SITE DEVELOPMENT PLANS

33 TOWNHOUSE UNITS

1525 & 1601 & 1603 & 1605 EAST 86TH STREET & 1604 & 1606 EAST 87TH STREET
BLOOMINGTON, MINNESOTA

REVISIONS	
04.28.26	CITY COMMENTS
05.12.26	REVISIONS
06.01.26	PLANS FINALIZED

SITE PLAN - SOUTH

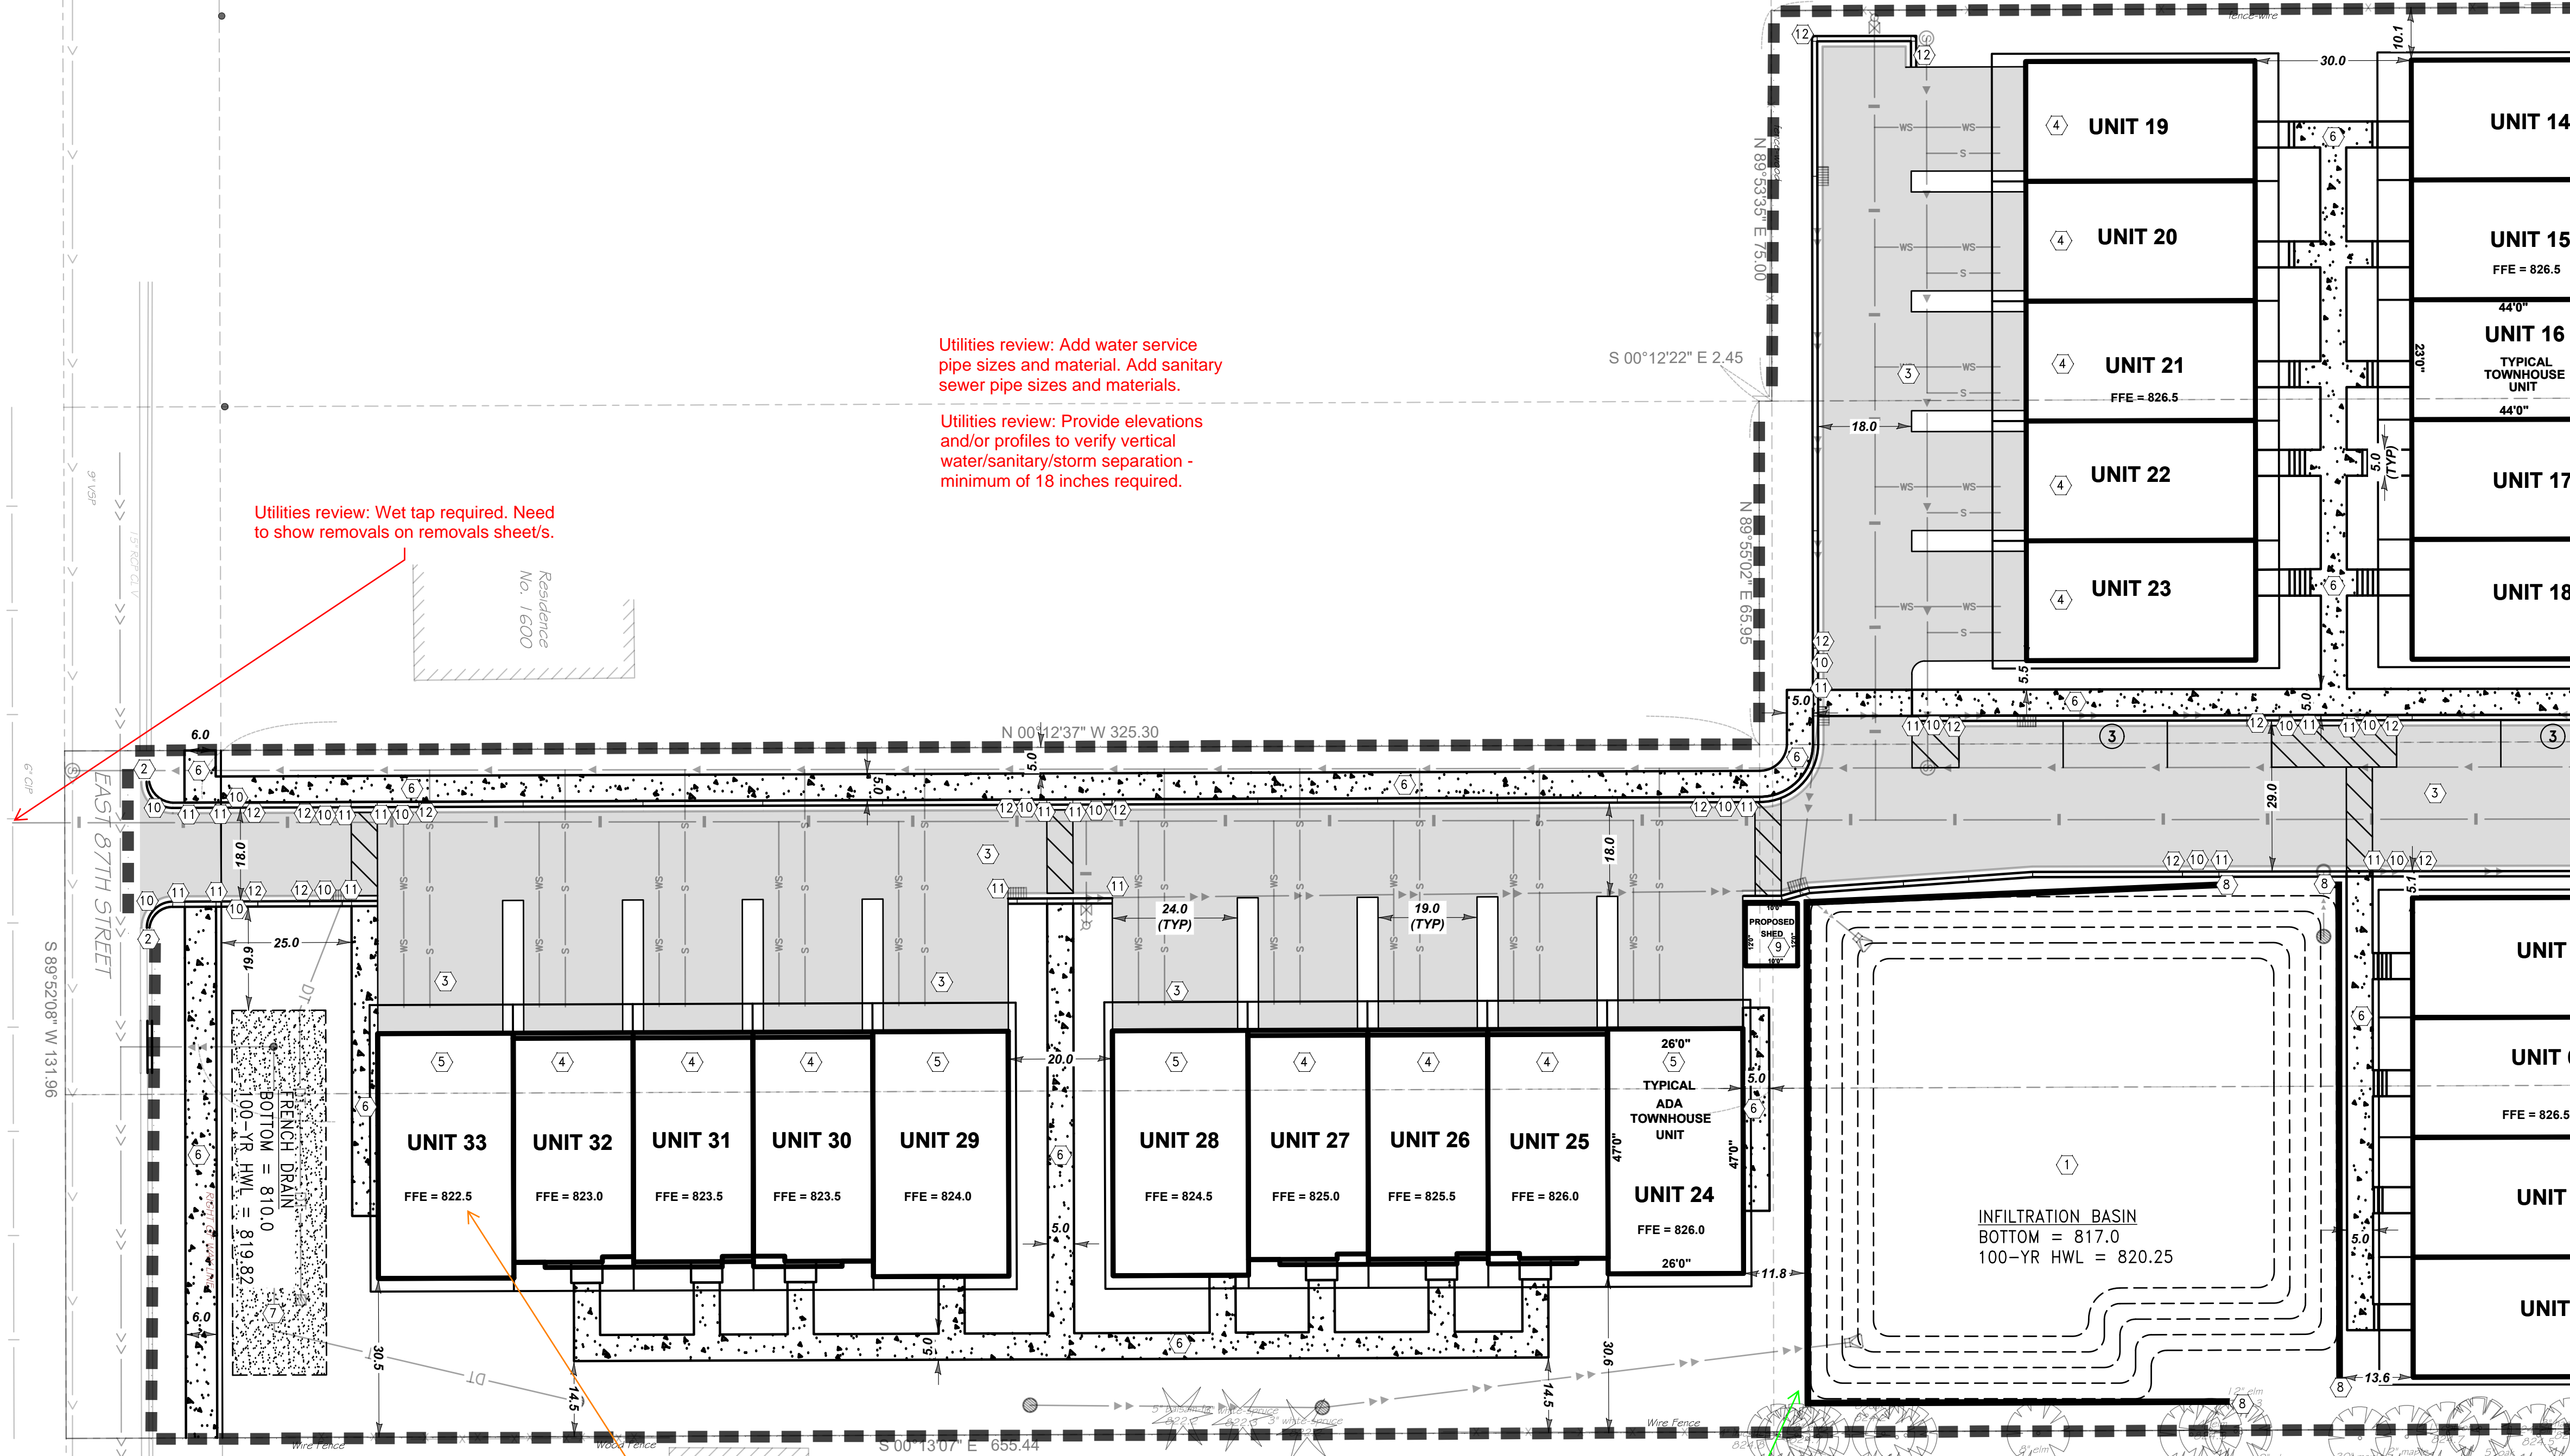
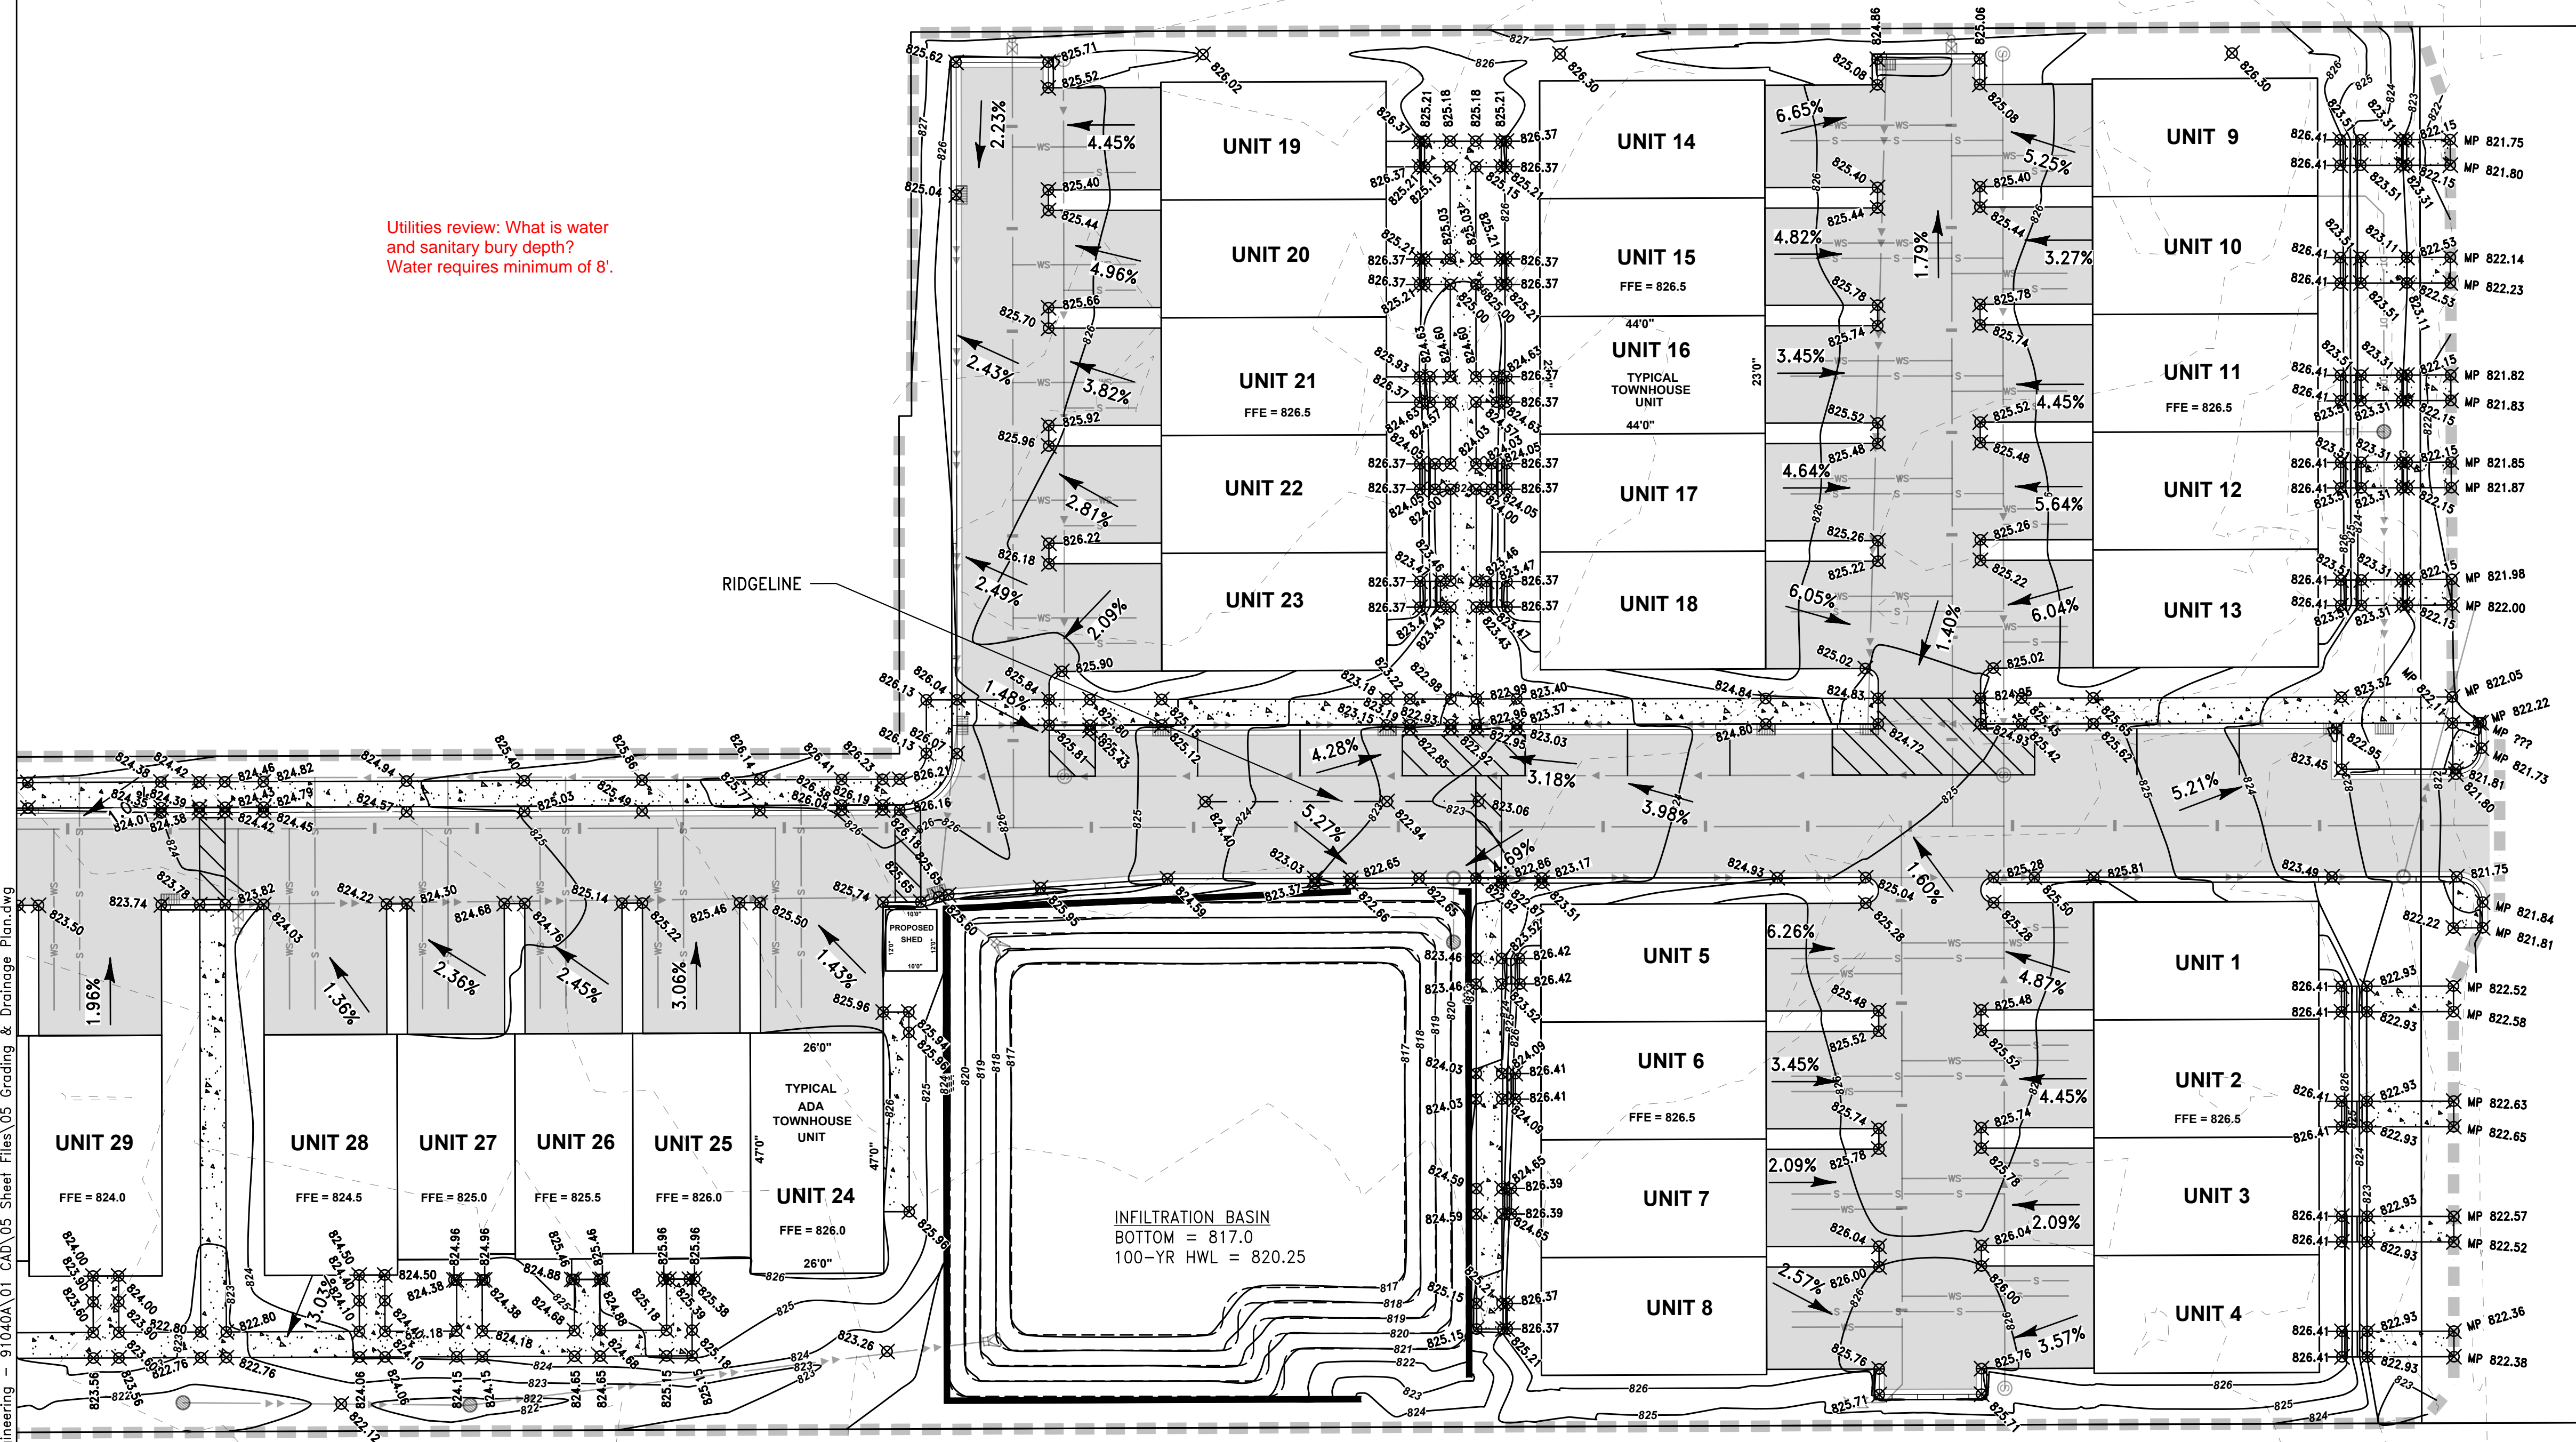
Utilities review: Add water and sanitary items to legend.

Utilities review: Add water service pipe sizes and material. Add sanitary sewer pipe sizes and materials.
 Utilities review: Provide elevations and/or profiles to verify vertical water/sanitary/storm separation - minimum of 18 inches required.

Utilities review: Wet tap required. Need to show removals on removals sheet/s.

Provide low floor elevations of proposed structures, not finished floor, to demonstrate compliance with freeboard requirements.

Submit groundwater mounding calculations to evaluate risk to adjacent basement due to proposed infiltration system(s).

Discrepancy: Retaining wall appears to be in a different place on the site plan. Retaining wall must stay out of easement.

GRADING & DRAINAGE PLAN
 - NORTH

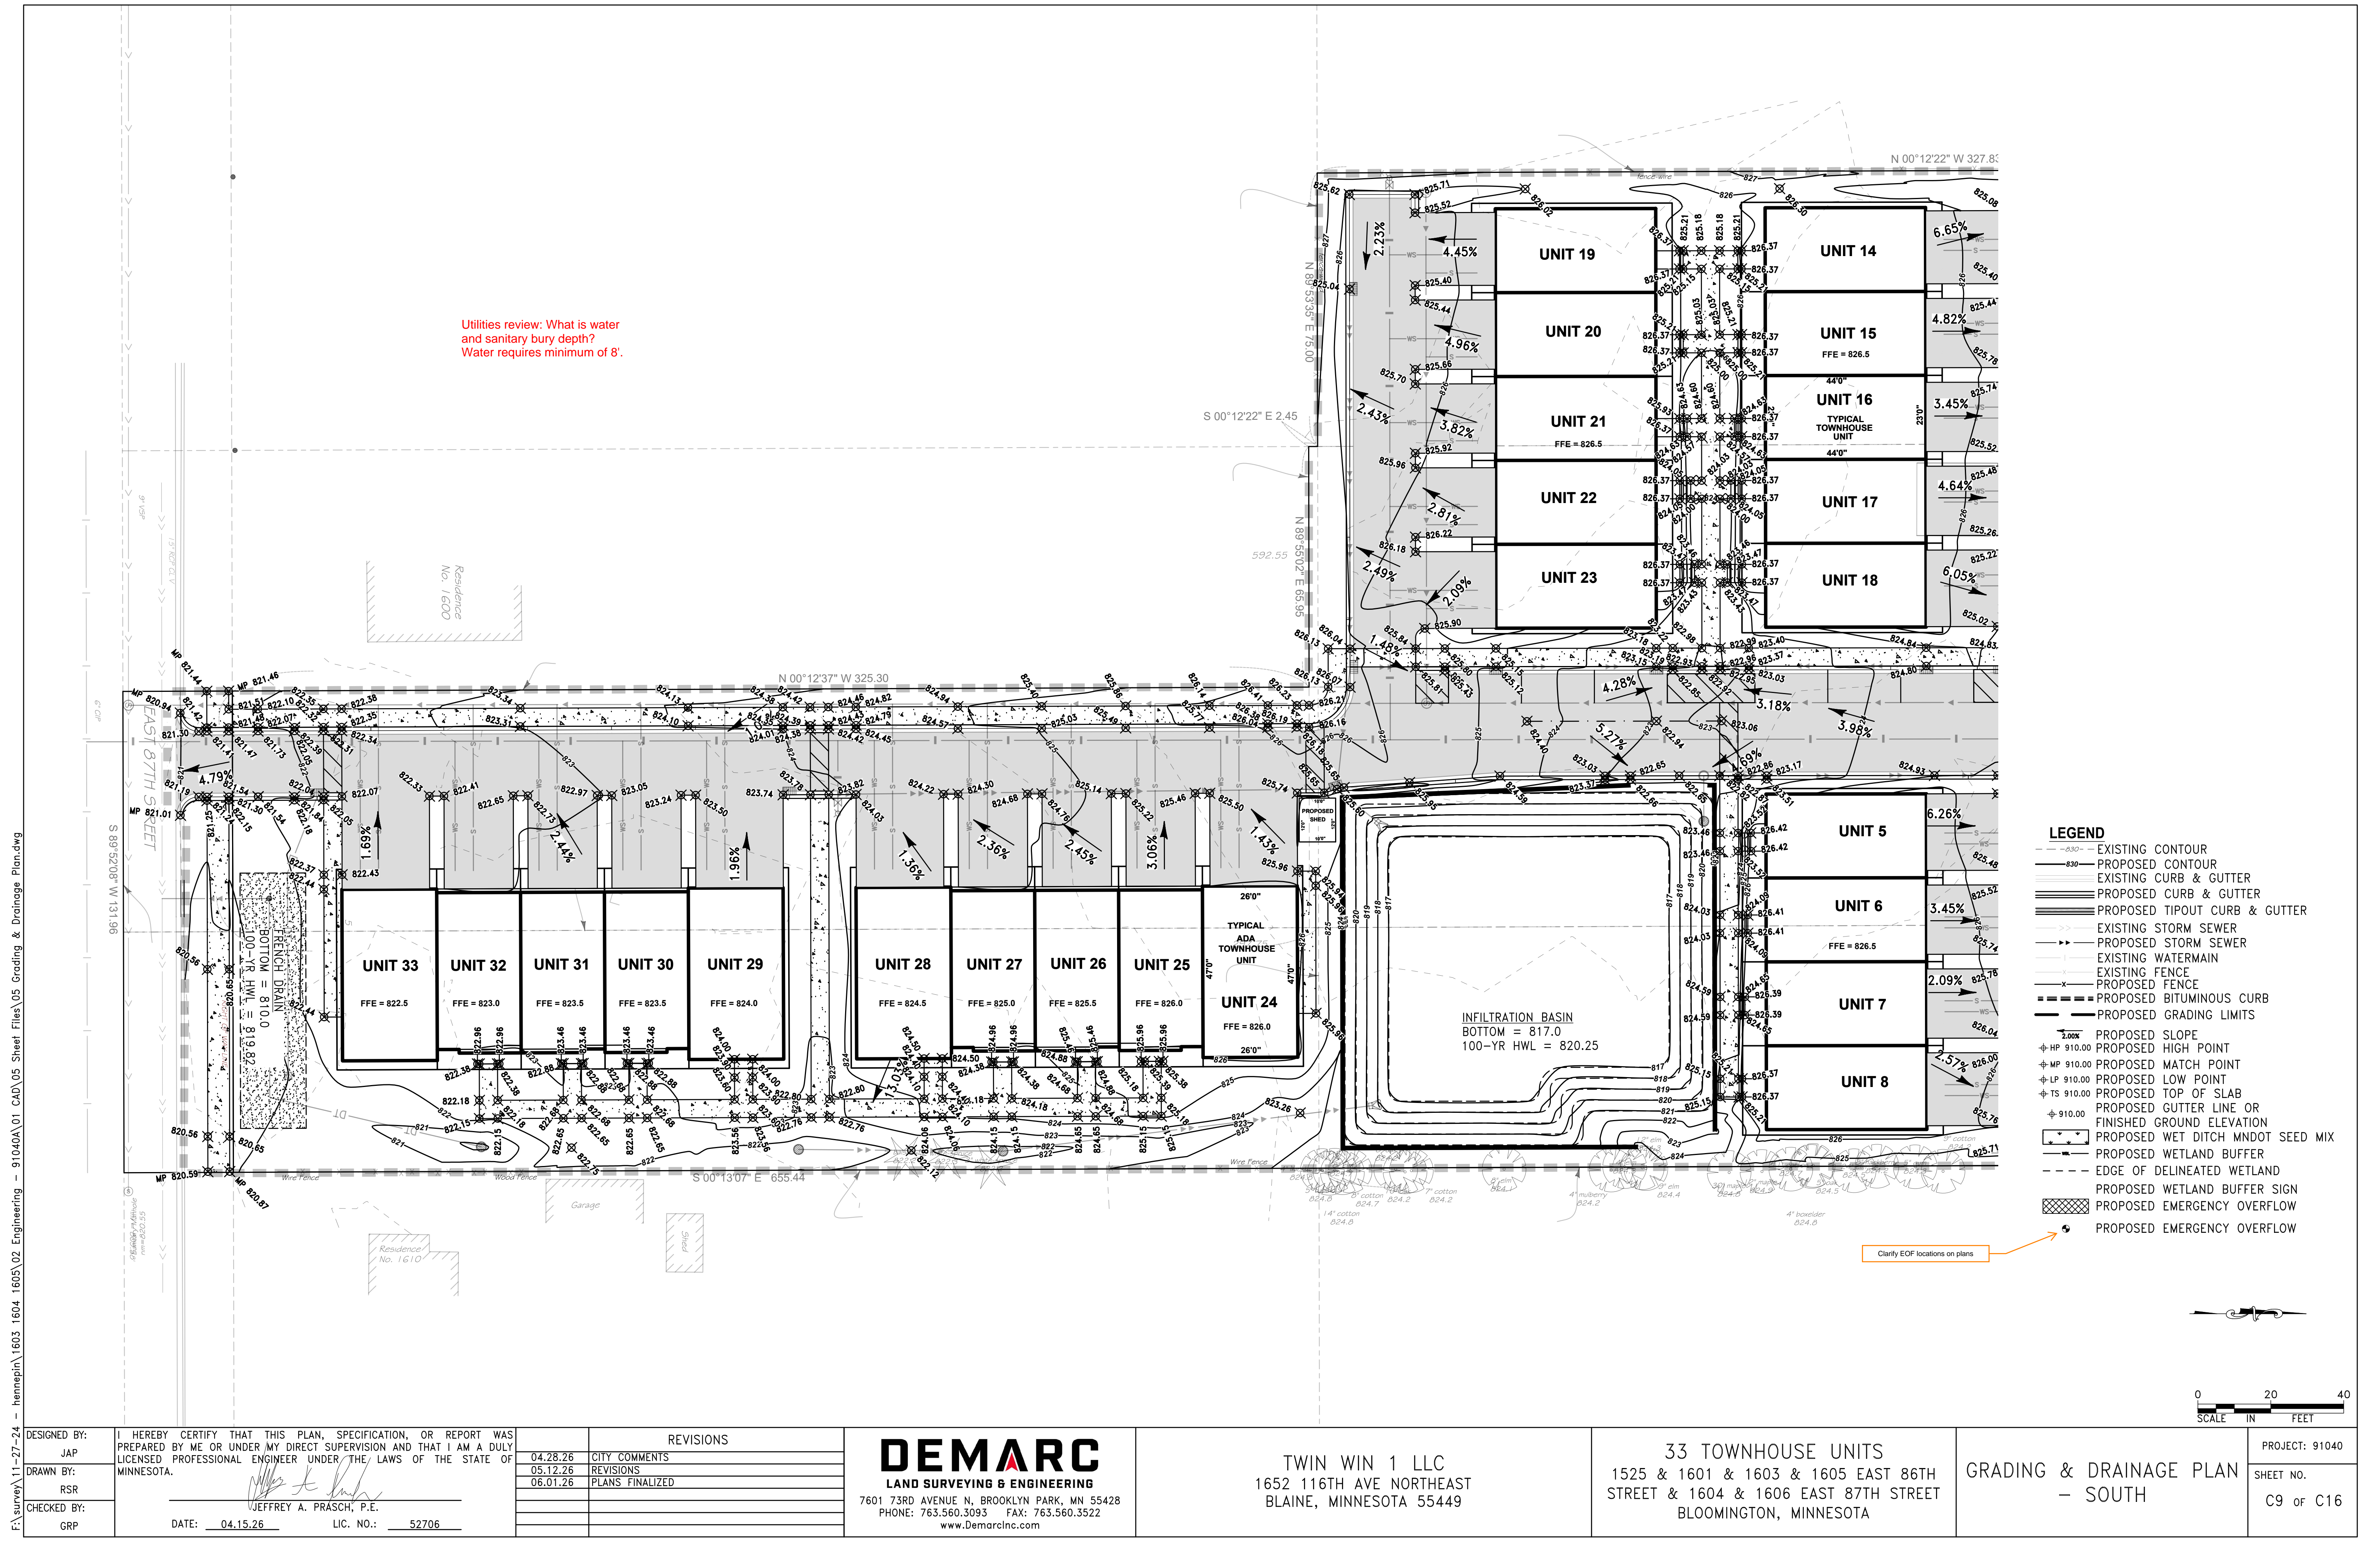
Utilities review: What is water and sanitary bury depth?
Water requires minimum of 8'.

Utilities review: What is water and sanitary bury depth?
Water requires minimum of 8'.

Clarify EOF locations on plans
